Re: Pio Pico Energy Center Project (11-AFC-01)
Biological Resources: Response to Ann Crisp's October 4, 2011 Inquiry

**PIO PICO ENERGY CENTER PROJECT
11-AFC-01**

**Supplemental Response to Biological Resources Data Requests
Responses to Email Correspondences from Ann Crisp, October 4, 2011**

EXHIBIT 1
 4/1-1/V051/V17

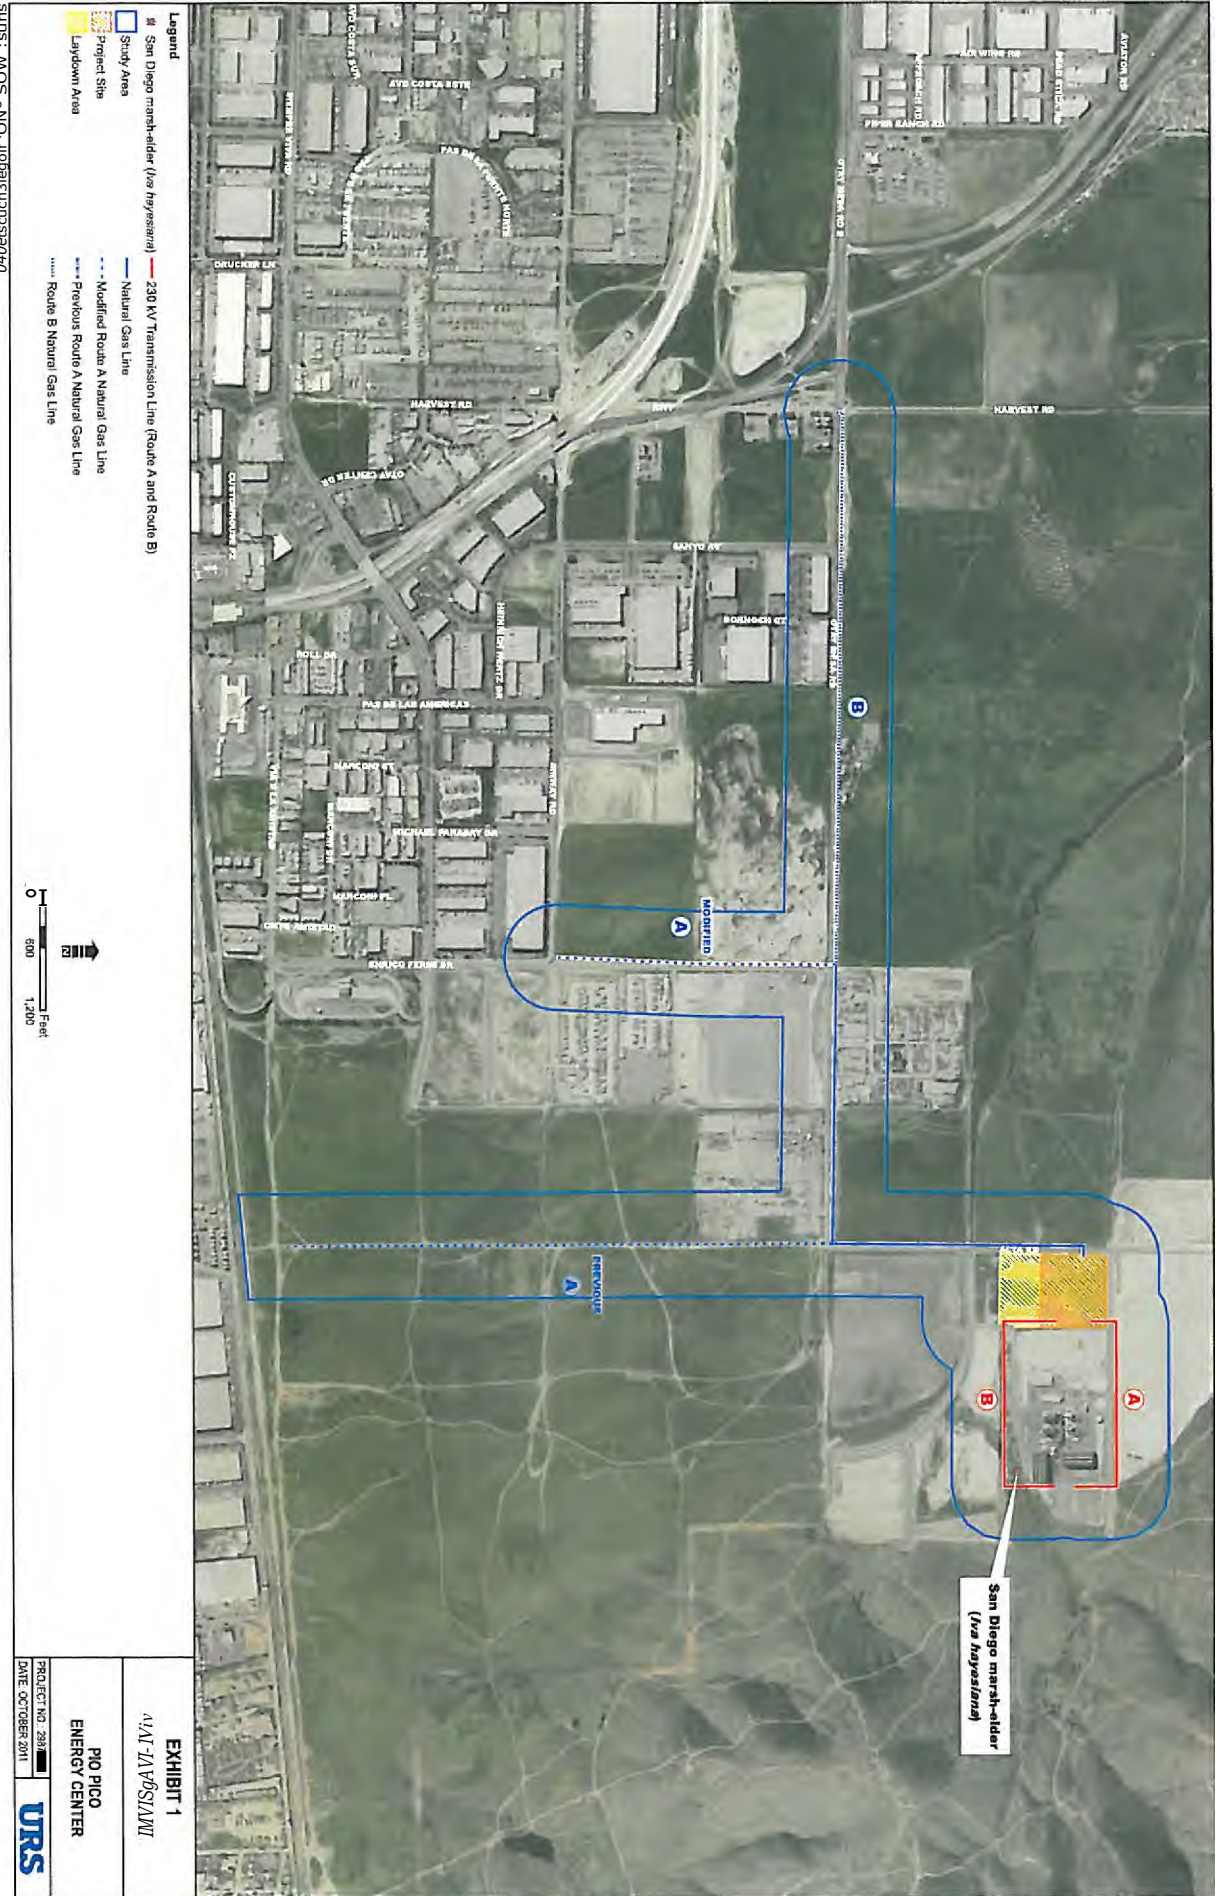
1. In reviewing the plant list it appears that San Diego marsh elder (*Iva hayesiana*) was detected during surveys of the project study area. There is no discussion of where this plant was found or a map indicating its location. Could you please provide details on this occurrence, where it is located, and if a CNDDDB form was completed and submitted to CDFG's CNDDDB? If you could provide as soon as possible that would be greatly appreciated.

San Diego marsh-elder (*Iva hayesiana*) is a perennial herb found in marshes and swamps, and a small population was detected within the drainage approximately 1,200 feet southeast of the project footprint and 200 feet north of the transmission line Route B option (Exhibit 1). Construction of the project will not result in temporary and/or permanent impacts to the San Diego marsh-elder because the drainage will not be impacted and the habitat requirements for this species do not occur within the project footprint. The facility placement and design, including placement of transmission line structures (i.e., Route **B**), were located and intended to avoid populations of special-status species and special aquatic resource areas within the region. The project design only includes the permanent removal of approximately 9.99 acres of non-native/developed habitat. A CNDDDB form for this occurrence has been submitted to CDFG. Furthermore, Mitigation Measure BIO 8 includes placement of a temporary Environmentally Sensitive Area (ESA) fence around the drainage to minimize habitat disturbance
